Access Compliance Report

Public Rights-of-Way

Intersection ID: 21800	Main Street: MILL_POND_RD	Cross Street: SCHOOL_HOUSE_LN	Location: S
ADA ID: 86171D4B8824	Ramp Type: PerpDiag	Initial Pass/Fail: Fail	Overall Compliance: No
		Severity Score: 22.5

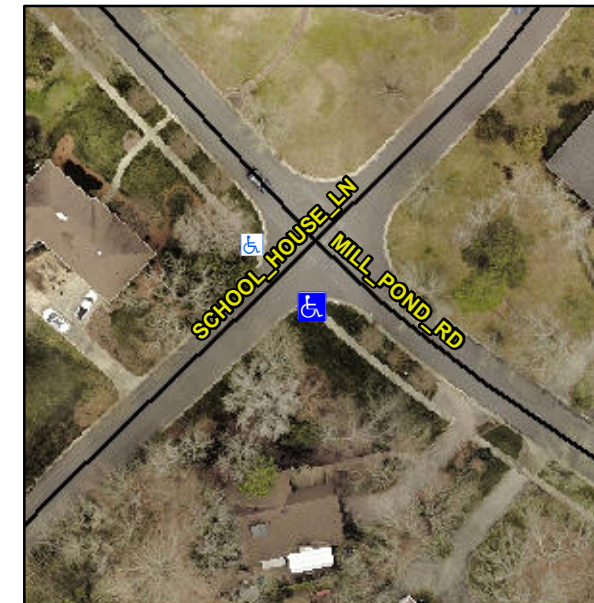
Not Found, R304.5.1, R304.2.2, R304.5.3

Compliance	Description	Data	Compliance	Description	Data
N/A	Ramp Length (in)	73.0	No	Ramp Slope (%)	10.2
No	Ramp Width (in)	45.0	No	Ramp XSlope (%)	4.5
N/A	Flare Type LT	N/A	N/A	Flare Type RT	N/A
N/A	Flare Slope LT (%)	N/A	N/A	Flare Slope RT (%)	N/A
N/A	Flare Traversable LT?	N/A	N/A	Flare Traversable RT?	N/A
N/A	Landing Length (in)	N/A	N/A	DWS Provided?	N/A
N/A	Landing Width (in)	N/A	N/A	DWS Contrast?	N/A
N/A	Landing Slope (%)	N/A	N/A	DWS Length (in)	N/A
N/A	Landing X Slope (%)	N/A	N/A	DWS Full Width?	N/A
N/A	Landing Curb? (Y/N)	N/A	N/A	DWS Offset (in)	N/A
N/A	Shared Landing?	N/A			
N/A	Gutter Ponding?	N/A	N/A	Gutter Slope (%)	N/A
N/A	Gutter Lip Ht (in)	N/A	N/A	Gutter X Slope (%)	N/A
N/A	Painted X Walk1?	No	N/A	Painted X Walk2?	No
	X Walk 1 Direction	To NE		X Walk 2 Direction	To NW
N/A	X Walk 1 Width (in)	N/A	N/A	X Walk 2 Width (in)	N/A
	X Walk 1 Slope (%)	6.0		X Walk 2 Slope (%)	2.5
	X Walk 1 X Slope (%)	1.0		X Walk 2 X Slope (%)	5.5

Remove & Replace Curb Ramp With Two New Directional Ramps or Equivalent.
